# Product Change Notification

Date Issued :	September 16, 2024	PCN Number :	515496
Reason for Change :	Change Supplier		
Description of Change :	This notification is to inform you about changes that are being made to the part(s) as identified in the list. This change results in a change in the raw material.		
Assessment of Change :	Reliability Test Report/s		
Planned Implementation Date :	March 16, 2025		
Customer Sample Availability Date:	September 17, 2024		
Last date to request Samples by Customer : October 17, 2024			
Please note if Samples are not requested as per Customer Samples Request date, it may take additional 4-6 weeks to arrange Samples.			
Traceability Code Markings / Date :	Lot information on label

## Change Overview: 3191 series raw material change

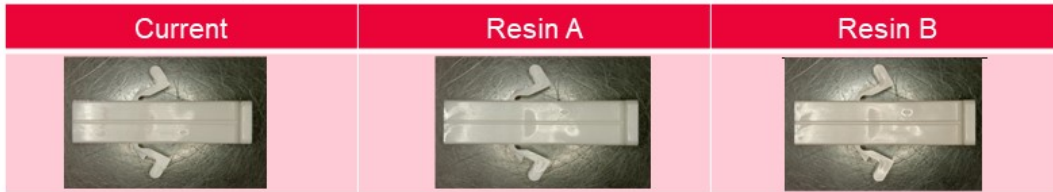
- The discontinuation of the additive (melamine) used in resin A (see bellow table) and it will no longer be able to supply material in its current formulation. The Melamine was newly added to the candidate list of SVHC for authorization under the EU REACH Regulation on January 17, 2023, but current material may contain more than 0.1wt% melamine as residual content in the product. Therefore, we will be switching to a new material that uses a new manufacturing method (using new melamine and changing the timing of addition). The new material, which has a changed manufacturing method, has a melamine content of less than 0.1 wt%.
- In addition to the above changes, new molding resin B will be added to prepare for possible future supply problems due to raw material shortages.
- This change applies only to products manufactured in Japan.

Current	After Change
Resin A (NYLON PA66 UL94V-0)	It may Contain more than 0.1wt% melamine	Contains less than 0.1wt% melamine
Resin B (NYLON PA66 UL94V-0)	-	Additional raw material resin
